Reconditioning of exhaust valve spindles

Do not recondition some spindle types until further notice

SL2023-735/AGC April 2023

Fig. 1: Exhaust valve spindle types

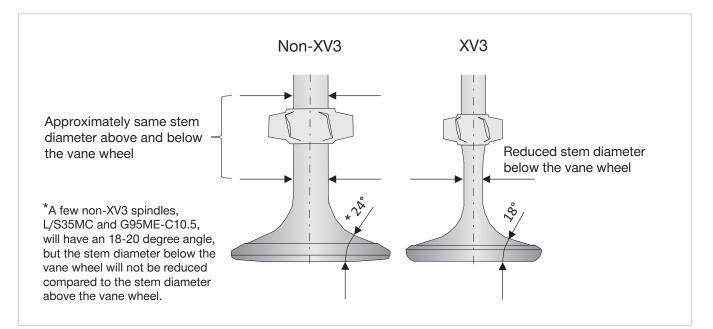
To distinguish between the spindle types, see Fig. 1.

All XV3 type spindles have:

- Smaller stem diameter below the vane wheel compared to above the vane wheel.
- 18° degree angle between the spindle disc bottom and the spindle disc top.

All non-XV3 spindles have:

- Approximately same stem diameter above and below the vane wheel.
- 24° degree angle between the spindle disc bottom and the spindle disc top (see Fig. 1).

Fig. 2: Spindle marking position

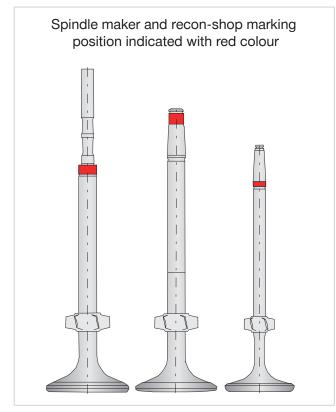
If the spindle marking was performed in accordance with MAN Energy Solutions guidelines, the following marking should clarify which spindle material was utilised originally when the spindle was new and prior to any reconditioning, see Fig. 2.

Spindle marking:

- SEAT
- HEAT RESISTANT LAYER

Fig. 3: Flow diagram - spindle types

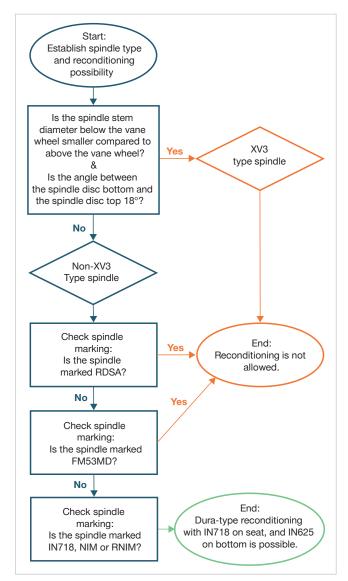
We recommend using the flow diagram in Fig. 3 and Table 1 to evaluate whether or not spindle reconditioning is possible.

Consequence		
No reconditioning available regardless of the spindle type		
No reconditioning available regardless of the spindle type

No reconditioning available if the spindle type is XV3
Dura-type reconditioning is available if the spindle type is non-XV3
Dura-type reconditioning is available if the spindle type is non-XV3
Dura-type reconditioning is available
